BEFORE THE ARIZONA CORPORATION COMMISSION

DOCKET NO. W-03512A-06-0407

**NOTICE OF FILING REBUTTAL
TESTIMONY**

Testimony of William F. Haney, P.E.

Attachment WFH1

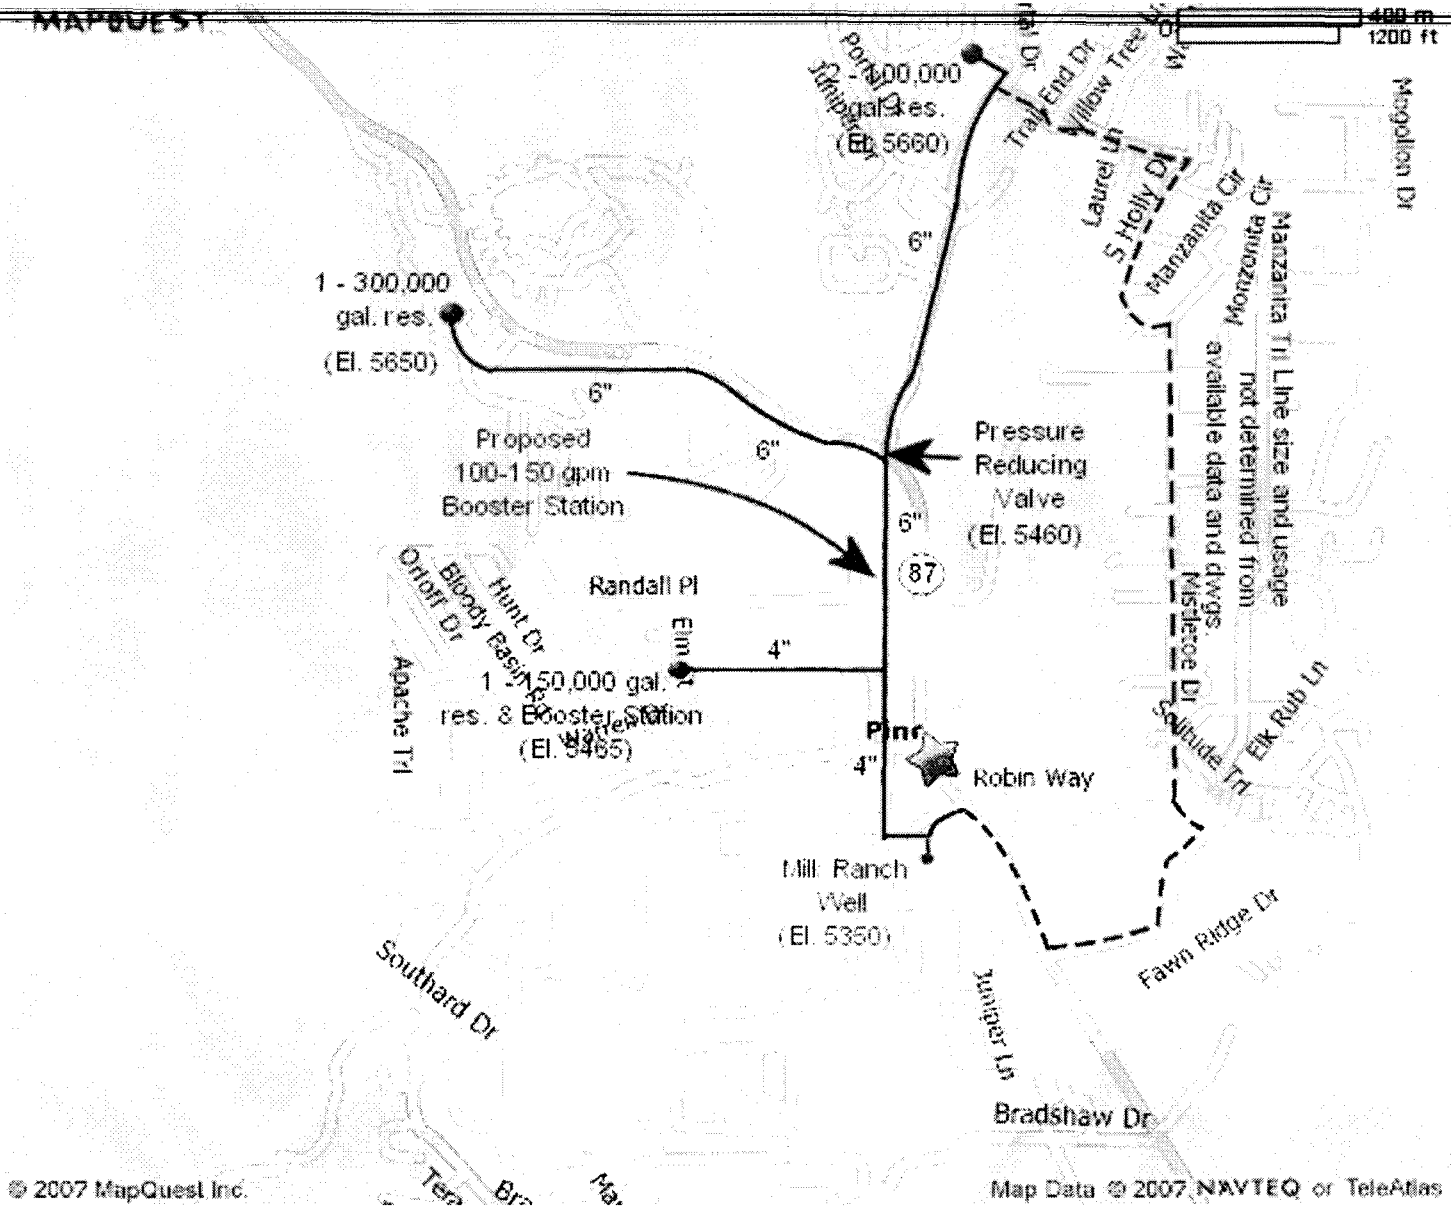
The layout directed by Hardcastle and estimated by Tetra Tech would install a booster station at the Milk Ranch site and an 8 inch pipeline from the well site to the 300K gallon tank in north Pine. While this layout will work and would be very simplistic to operate, in my opinion, it is a very high cost option when other options are available at a significantly lower cost to construct and would also result in substantially lower operating costs.

As indicated on Attachment WFH1, the existing distribution system (according to E&R System Maps dated 1987) has distribution lines (6 inch) running southeast along Hwy. 87 from the 300K tank to the intersection of the alignment of North Pine Creek Drive. The line then turns south and follows North Pine Creek to the southern property line of the community school. A 4 inch line then runs west to a 150,000 (150K) gallon tank at the end of Watertank Road. The north-south line also continues south on Pine Creek Drive as a 4 inch line to the intersection with North Road. At this point a line extends to the east across Pine Creek and is within 250 feet of the Milk Ranch Well. Milk Ranch could be connected at this point and could provide water to the 150K tank which in turn, supply's most, if not all of the water to Pine Water Company's service area to the south and west of Hwy. 87 (roughly half of the total service area). If a small

(100-150 GPM) booster station were installed somewhere on the 6 inch line north of the southern property line of the school on North Pine Creek Drive, then additional capacity from the well could be delivered to the northern pressure zone within the community. As the northern zone "floats" off of the 300K tank, any water entering that pressure zone would then be available for use in the entire system north and east of Hwy. 87 and water could also be delivered to Strawberry if needed.

A preliminary estimate of costs to accomplish the above would be approximately \$20,000 to connect Milk Ranch to the 4 inch line and between \$110,000 and \$150,000 to construct the small booster station.

It should also be noted that use of the 4 inch line to deliver 150 GPM of water would result in a flow velocity of 3.2 feet per second in the pipe. Good engineering practice dictates that velocities of less than 4 feet per second are desirable. Hence, use of the 4 inch line could easily accommodate production from the well. Also, by using the existing distribution system to move the water, only about half of the water would be pumped to the upper zone, thereby resulting in additional energy savings (under the BUI layout, all of the water would be pumped to the 300K tank and then much of that water would then flow back down the system through a pressure reducing valve and into the lower pressure zone and 150K tank). Finally, it should be noted that boosting the water would result in a significant increase in line pressures (approx. 80 psi) from the proposed booster station to the intersection of North Pine Creek Drive and Hwy. 87 and this segment of line may require rehabilitation/replacement if line breaks become a problem. All other segments of the system would continue to "float" on the existing storage reservoirs at existing system pressures.

While the layout will work and is very simplistic in concept, in my judgment it is a very costly and inefficient method of connecting the well. As previously stated, a design using a layout similar to Attachment WFH1 would utilize existing pipe and result in much lower operating expenses as only the water needed in the upper pressure zone would require booster pumping. Additionally, the most if not all, of the community south and west of Hwy. 87 could be served with minimal construction effort and water that was previously delivered from north to south could be retained in the upper pressure zone, thereby easing shortages there.

In addition to the above, use of an 8 inch line seems overkill and only adds to the cost of the project without providing benefit. While such size would be desirable for future fire protection as stated, it would be unusable for such purposes if the pipeline were a dedicated transmission main that discharged to the top of the 300K tank. No fire flow storage would be available under this scenario and only the well production would be available. If that same line connected to the bottom of the 300K tank, then it would be equally effective to merely connect the new pipeline to the existing at the intersection of North Pine Creek Drive and Hwy. 87, saving hundreds of thousands of dollars in pipeline costs.

Based upon the system layout indicated on the E&R Maps and available system hydraulics, the Milk Ranch Well is located in an excellent location for supplying nearly half of the service area with a simple connection to the existing system as described in my previous response. The entire system including Strawberry could be served by adding only a small booster station.

Connecting the well to the system with no other improvements would allow the Milk Ranch Well to serve most of the Pine Water service area west and south of Highway 87 for approximately \$20,000. This would also allow the remainder of the system to utilize well capacity freed up by Milk Ranch. While this one connection would not alleviate the long term supply in Pine, would provide some much needed, immediate relief for the customers.
